Service Bulletin

Bulletin No.: 19-NA-013

Subject: Ticking or Popping Noise at Roof Rail Assist Handle(s)

Brand:	Model:	Model Year:		VIN:		Engine:	Transmission:
		from	to	from	to		
Chevrolet	Equinox	2018	2019			All	All
GMC	Terrain						
Holden	Equinox

5222304

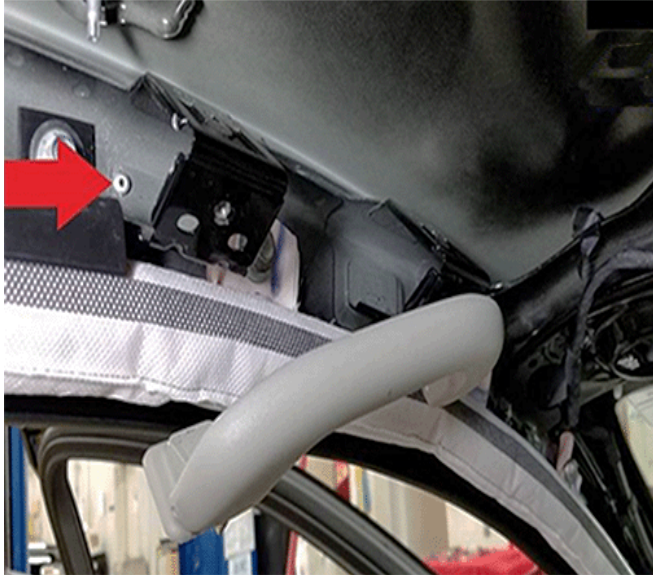
2. Using a 1/8 inch (3.175 mm) drill bit, drill a hole (location shown by arrow in the graphic above) at all the affected assist handle bracket locations. Left, front location is shown above, right side would be similar.
3. Obtained locally, install a common 1/8 inch (3.175 mm), dome head rivet, or equivalent, at the drill location(s).
4. Verify condition has been corrected, then reinstall the headliner. Refer to *Headlining Trim Panel Replacement*, in SI.
